RE: Addendum No. 1 – Waller County Bid 25-002 – Construction of Justice Center Vehicle Maintenance Garage

ADDENDUM #1

To the plans and specifications for:
Waller County – Vehicle Maintenance Garage
200 Sheriff R Glenn Smith Dr.
Hempstead, TX 77445

OVERALL SITE PLAN
A-001

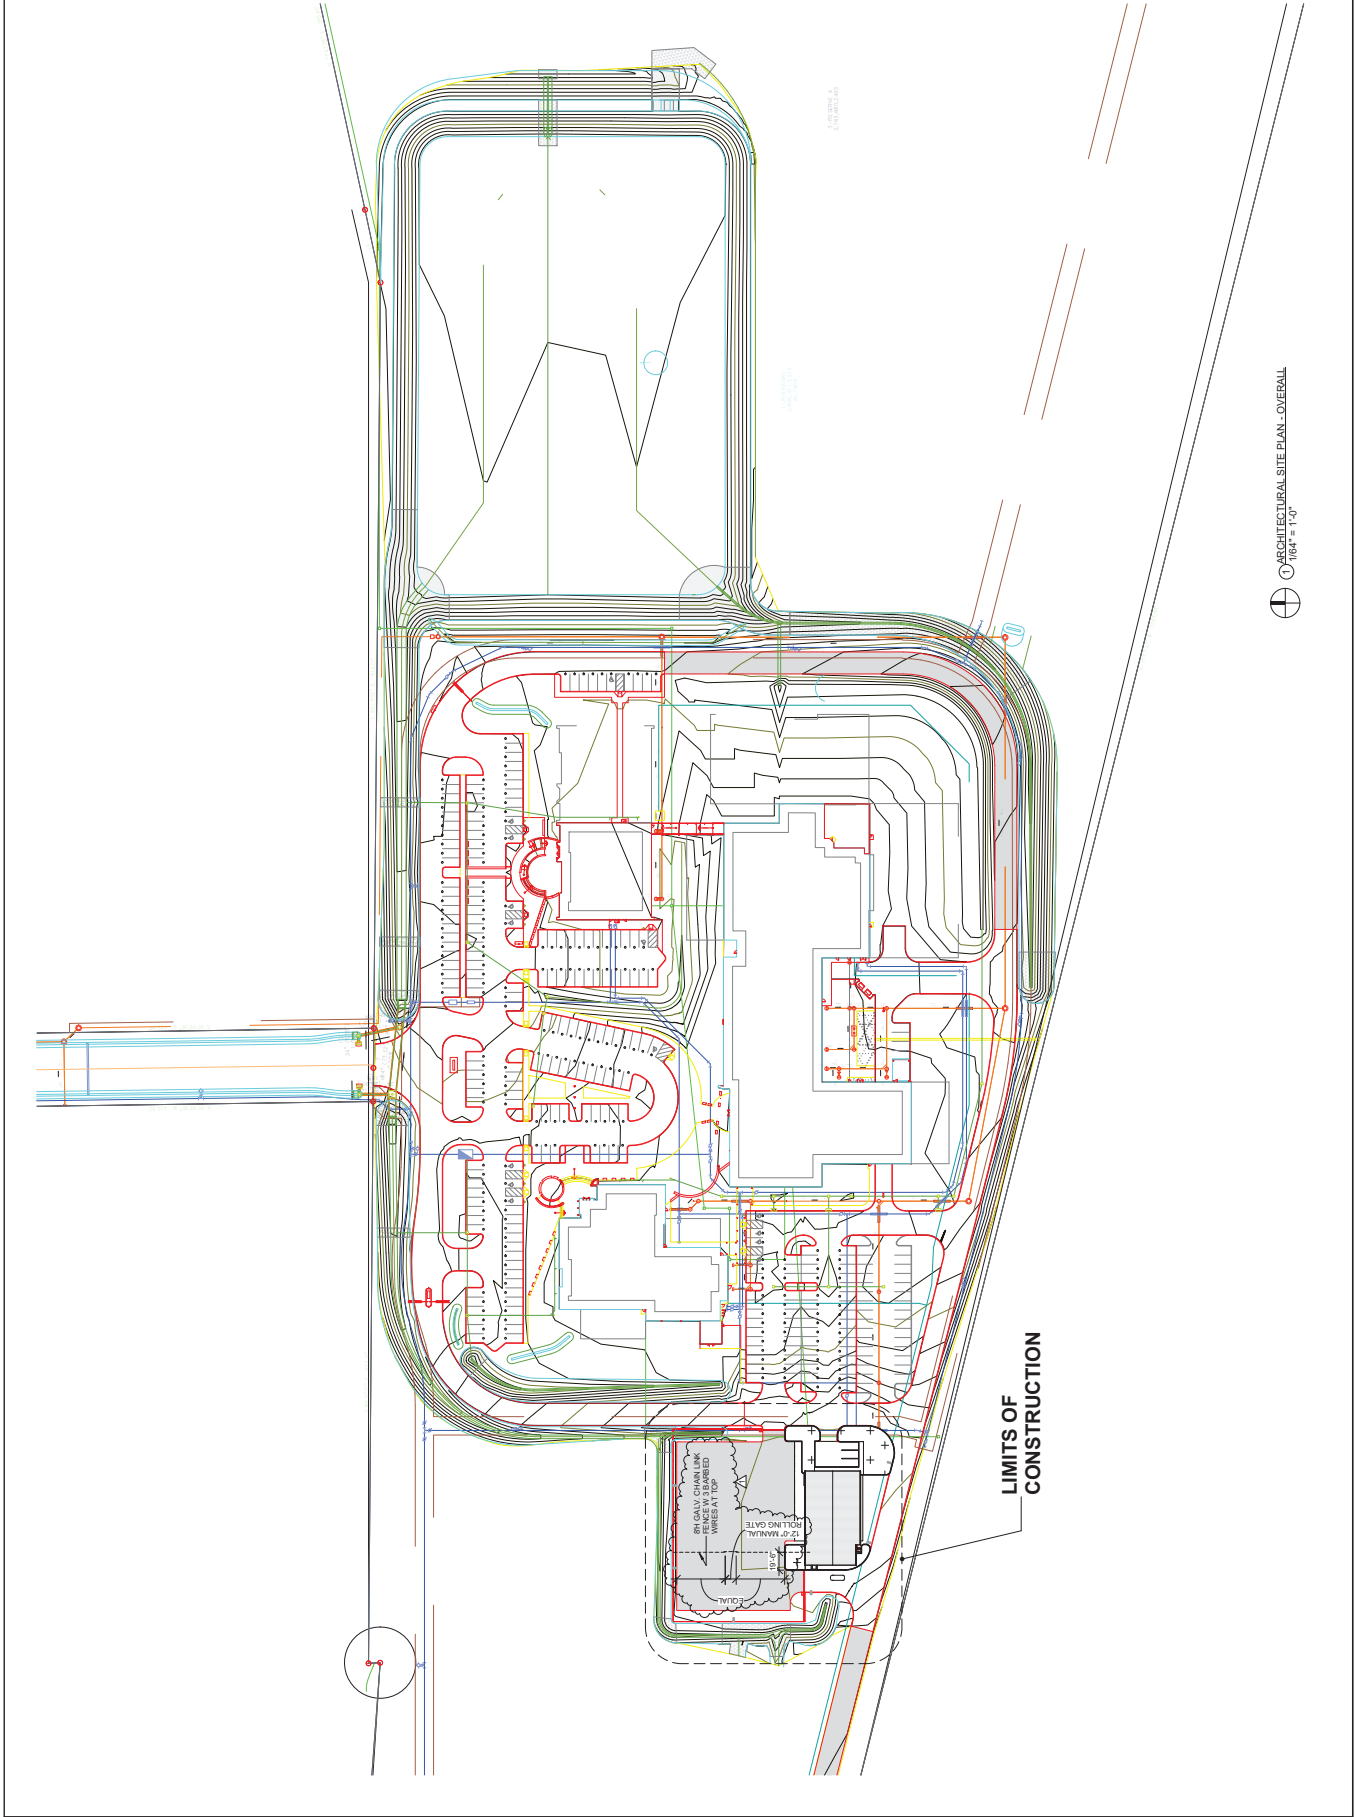
1. An internal chain link fence with manual sliding gate has been added. See revised sheets A-001, A-002, & A-101.
2. The west car lift will be installed at a later date. All infrastructure is still to be provided. See revised sheet A-101.
3. Floor and wall finishes have been revised. See revised sheets A-421 & A-811.

5. Sheet A-001 Overall Site Plan:

- a. An internal chain link fence with manual sliding gate has been added.

15 10" GALV. CHAINLINK FENCE W/3
BARBED WIRES AT TOP, MATCH
EXISTING, FIELD VERIFY, WITH
MANUAL ROLLING GATE, 12" CLEAR

FINISH PLANS & SCHEDULE

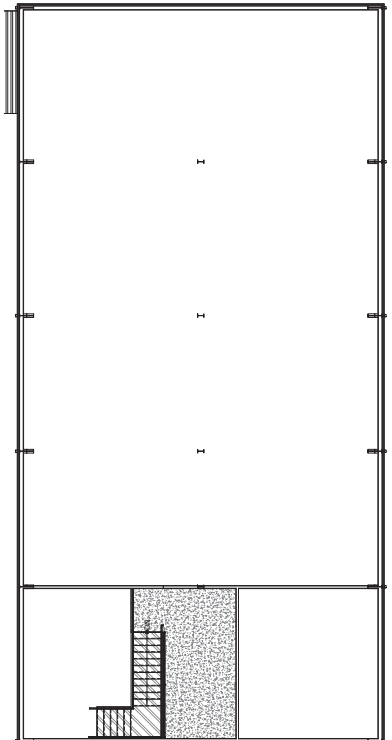
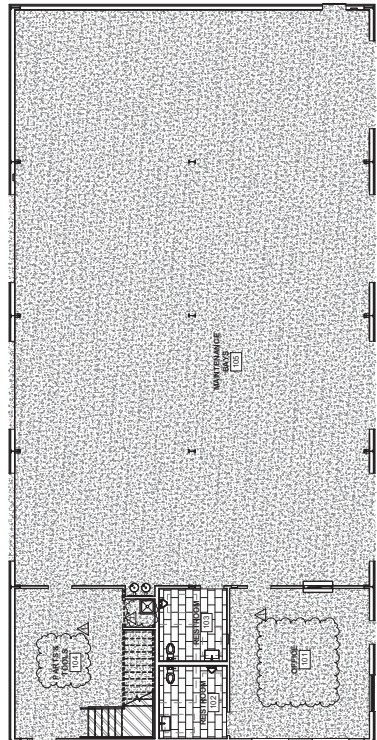
9. Sheet A-811 Finish Plans & Schedule:

- a. Floor and wall finishes have been revised.

Answer: To clarify, tile is only in the restrooms, and the remainder of building floor finish is sealed concrete. The following flooring specs are currently provided in the Specification Manual: 09310 Porcelain Tile, 09651 Resilient Floor Tile [for wall base, accessories, and stairs]. Resilient Floor Tile Specification is limited to wall base and stair accessories (only). The VCT floor tiles and Carpet Tile products have been deleted from this project. Standard concrete sealer is the balance of the project's floor finish as currently provided in specification 03300 Cast In Place Concrete. See Addendum #1 for additional clarifications regarding floor finishes to be provided.
